**STATE OF NEW YORK
PUBLIC SERVICE COMMISSION**

CASE 12-T-0502 - Proceeding on Motion of the Commission to Examine Alternating Current Transmission Upgrades.

CASE 13-E-0488 - In the Matter of Alternating Current Transmission Upgrades - Comparative Proceeding.

CASE 13-T-0461 - Application of Boundless Energy NE, LLC for a Certificate of Environmental Compatibility and Public Need Pursuant to Article VII for Leeds Path West Project.

Figure 1 - Conductor comparison showing ampacity capabilities, attainable at recommended thermal limits of several conductor types. The ACCC® conductor delivers greater emergency current at 200°C than other conductors operated at temperatures as high as 250°C.

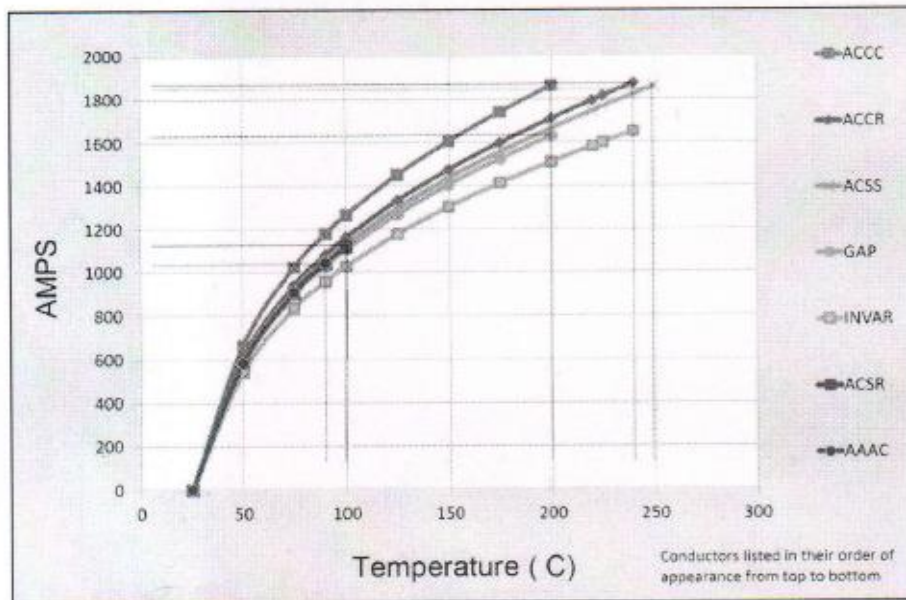
More importantly, due to the composite core's decreased weight compared to steel, an ACCC® Drake size conductor, for instance, could incorporate 28% more aluminum using compact trapezoidal shaped strands, with a slight overall reduction in weight. The added aluminum content and improved conductivity of the annealed Typed 1350-O aluminum used in ACCC® conductors (63% IACS) allow them to operate more efficiently compared to any other commercially available conductor of the same diameter and comparable weight. The ACCC ® conductor achieves the highest ampacity at the coolest operating temperature compared to the other high temperature capable conductors, as shown in Figure 1 below.⁸²

The ACCC conductor is the top curve in Figure 1. In short, there is no support in the record for Trial Staff's assertion. In fact, just the opposite is true, as Trial Staff's own reference (see Footnote 41 to the Final Report) makes clear. The lighter weight core of ACCC conductor allows the incorporation of approximately 28% more aluminum for ACCC conductors compared to conventional conductors of the same diameter and weight. The added aluminum content reduces the conductor's electrical resistance and reduces line losses by 25 to 40%. The key to this result is that ACCC conductor operates cooler than competing conductors at the same load conditions. The source relied upon by Trial Staff on P. 150 of the Final Report makes this point.⁸³
